SUBJECT: Forwards response to request concerning addl info on
 responses to NRC short-term requirements for auxiliary
 feedwater sys.

Donald C. Cook Nuclear Plant Units 1 and 2
Docket Nos. 50-315 and 50-316
License Nos. DPR-58 and DPR-74

June 26, 1980
AEP:NRC:00307C

ATTACHMENT TO AEP:NRC:0307C

FIGURE 1

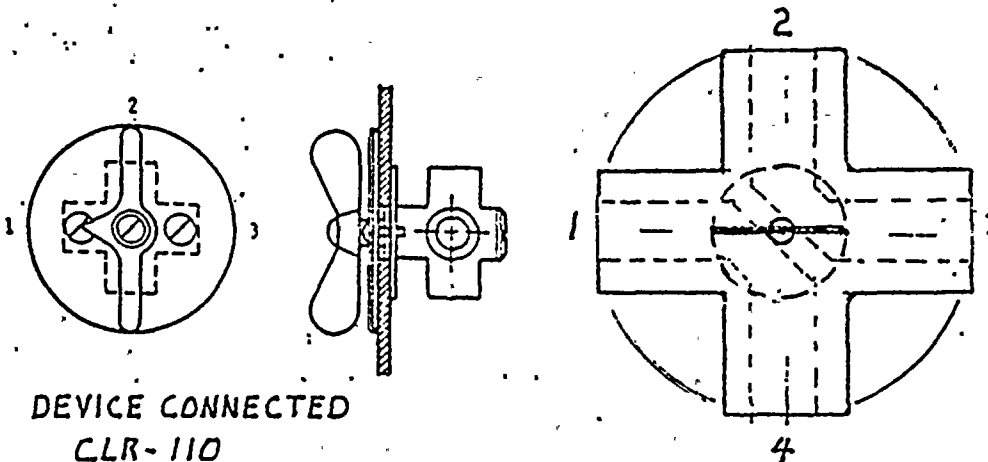
We were requested by the NRC staff to document the information provided during recent telephone discussions concerning this recommendation.

The pneumatic air selector switch is a Foxboro Model 38360 two (2) position, four (4) port transfer switch. Figure 1 depicts the materials of construction, schematic tubing arrangement and physical outline of the switch. Port #1 is used for one train of level indication tubing and is designated as CLR-110. Port #3 is used for the redundant train of level indication tubing and is designated as CLR-111. Port #4 is used for the recorder connection while Port #2 is plugged. The 'manual' position of the switch connects CLR-110 to the recorder and the 'automatic' position connects CLR-111 to the recorder (the actual switch mounted on the panel has on it designations CLR-110 and CLR-111, respectively).

The power supply for the control room annunciators/alarms is from the 250 volt station batteries. The respective alarms for CLR-110 and CLR-111 are powered electrically by DC power bus CAB-AFC-1. The alarm modules are Mercoid and United Electric pressure switches located in the back of the main panel on its respective train of pneumatic tubing between the sensor and the pneumatic air switch.

All single failures which could affect the CST level indication would result in actuating the Lo and Lo-Lo alarms on one or both trains. By procedure after verifying a true alarm, the operator will switch to the backup water source (EWS) for auxiliary feedwater supply upon actuation of the alarms. This action places the AFS into its most conservative mode of operation whether or not there is water in the CST. Further, the automatic low suction pressure pump trip being installed in response to NRC recommendation GL-4, trips the pump independently of the CST level indication and alarms. This auto pump trip is itself alarmed. In the event that the operator does not adequately respond to the CST level indication and alarms during the time span from the Lo-Lo alarm to pump trip, pump damage due to loss of suction is prevented automatically by the trip function.

FIGURE 1

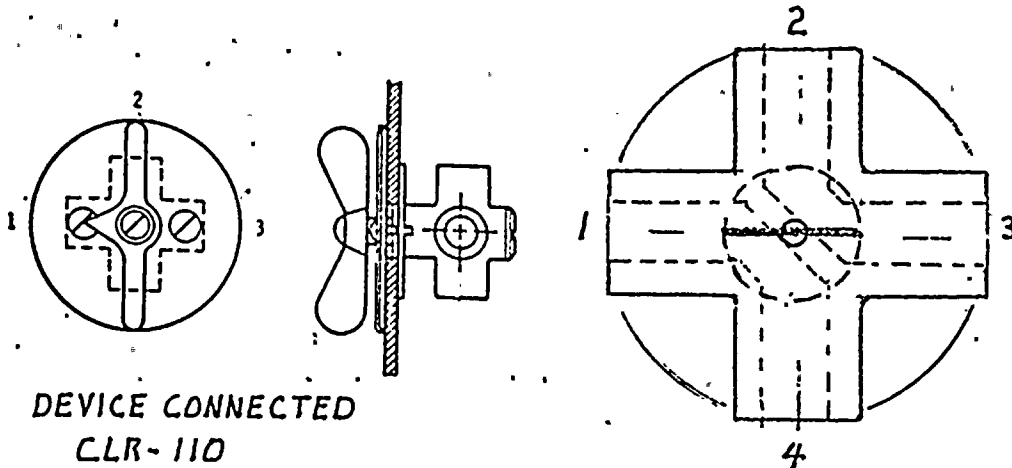
We were requested by the NRC staff to document the information provided during recent telephone discussions concerning this recommendation.

The pneumatic air selector switch is a Foxboro Model 38360 two (2) position, four (4) port transfer switch. Figure 1 depicts the materials of construction, schematic tubing arrangement and physical outline of the switch. Port #1 is used for one train of level indication tubing and is designated as CLR-110. Port #3 is used for the redundant train of level indication tubing and is designated as CLR-111. Port #4 is used for the recorder connection while Port #2 is plugged. The 'manual' position of the switch connects CLR-110 to the recorder and the 'automatic' position connects CLR-111 to the recorder (the actual switch mounted on the panel has on it designations CLR-110 and CLR-111, respectively).

The power supply for the control room annunciators/alarms is from the 250 volt station batteries. The respective alarms for CLR-110 and CLR-111 are powered electrically by DC power bus CAB-AFC-1. The alarm modules are Mercoid and United Electric pressure switches located in the back of the main panel on its respective train of pneumatic tubing between the sensor and the pneumatic air switch.

All single failures which could affect the CST level indication would result in actuating the Lo and Lo-Lo alarms on one or both trains. By procedure after verifying a true alarm, the operator will switch to the backup water source (EWS) for auxiliary feedwater supply upon actuation of the alarms. This action places the AFS into its most conservative mode of operation whether or not there is water in the CST. Further, the automatic low suction pressure pump trip being installed in response to NRC recommendation GL-4, trips the pump independently of the CST level indication and alarms. This auto pump trip is itself alarmed. In the event that the operator does not adequately respond to the CST level indication and alarms during the time span from the Lo-Lo alarm to pump trip, pump damage due to loss of suction is prevented automatically by the trip function.
